**ADVISORY REPORT
 FINDINGS, CONCLUSIONS, AND RECOMMENDATIONS**

Date: October 29, 2013

File: SUB13-00456, SAR13-00457; CEDARBROOK SHORT PLAT AND BUFFER
 MODIFICATION PERMIT

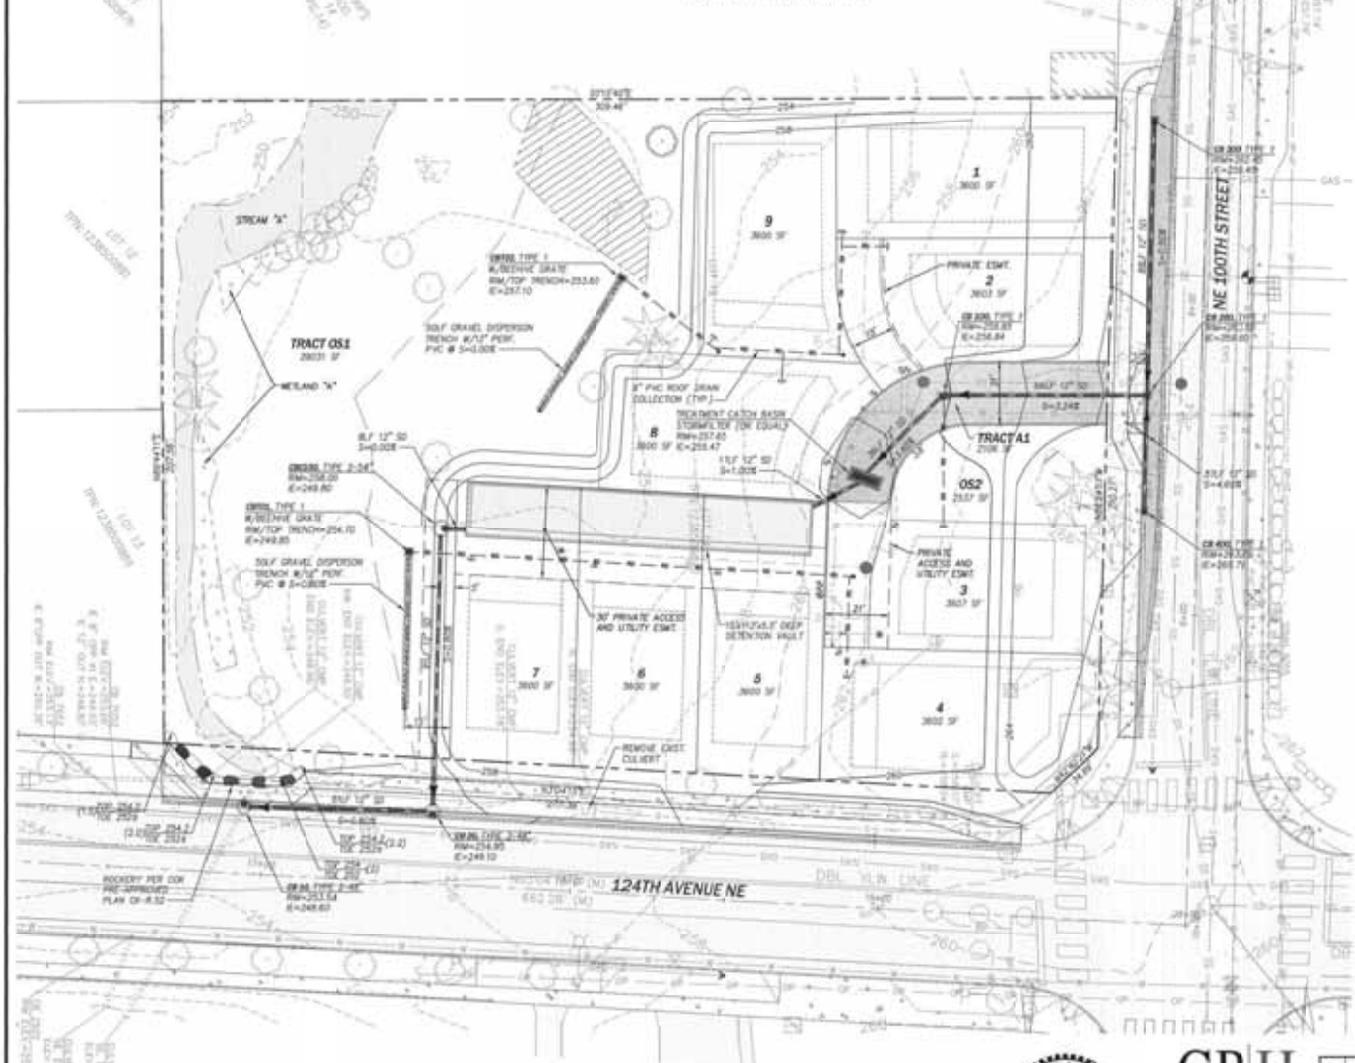
We recommend that the enhanced buffer be extended beyond the proposed 50' line into areas south and west of the constructed houses at lots 7, 8 and 9 and the stormwater infrastructure as shown on Sheet 3 of 4 for the proposed plat. Native trees should be planted in this expanded area to increase riparian functions. It should also be noted that since Wetland A has a surface water connection to Forbes Creek (based on the 2011 Watershed Company report) it may be used by salmonids in addition to the Forbes Creek tributary.
